1, 5, 5A, 7 GLADYS AVENUE

FRENCHS FOREST NSW

DA Submission
February 2023

3.0 PLM & DSAP & Design Evolution / 3.01 Overview

Other Matter - Adjacent Site at 3 Gladys Ave

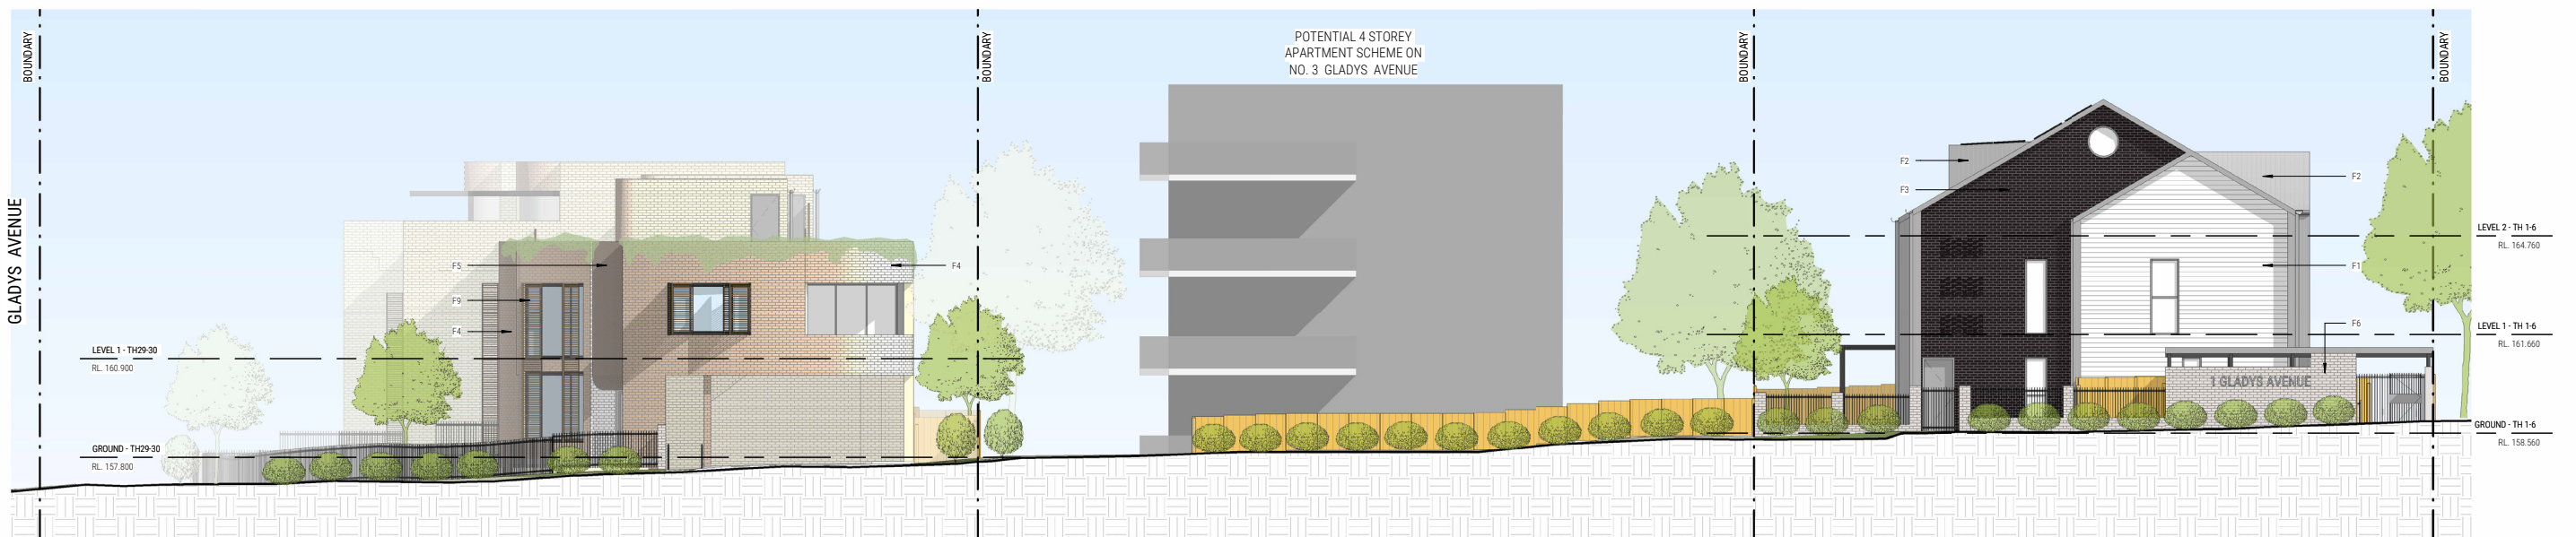
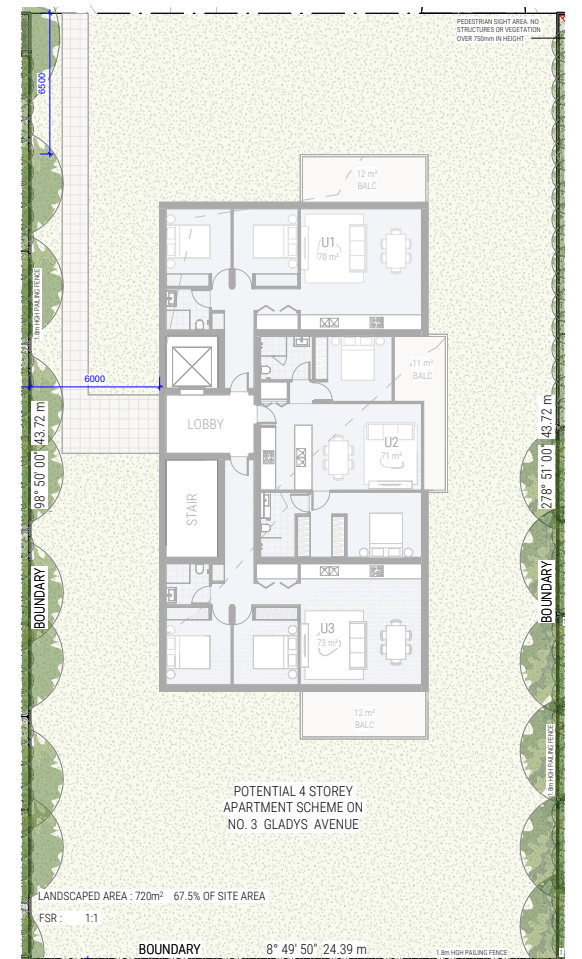
Site isolation raised. Also, that Council planners considered LEP clauses 8.6 and 8.7 to be potential impediments to the proposed development of the subject land. Legal advice was sought and attached. It confirms that LEP clauses 8.6 and 8.7:

- Are not prohibitions
- Are development standards
- Does not pose an impediment to the development of the subject land in the manner proposed.

Further detailed work has been done

- Two schemes have now been prepared: one for multi-dwelling house and one for a Residential Flat Building; the RFB is shown in the updated plan set.
- 12 units – 11 receive 6hrs, 1 receives 5hrs
- FSR of 1 to 1 which is higher than the subject site and therefore achieves a reasonable development outcome
- Compliant building height (4 storeys) and landscaped area of 67.5%.
- Independent valuation of the land is done and multiple attempts to purchase the site are unsuccessful.
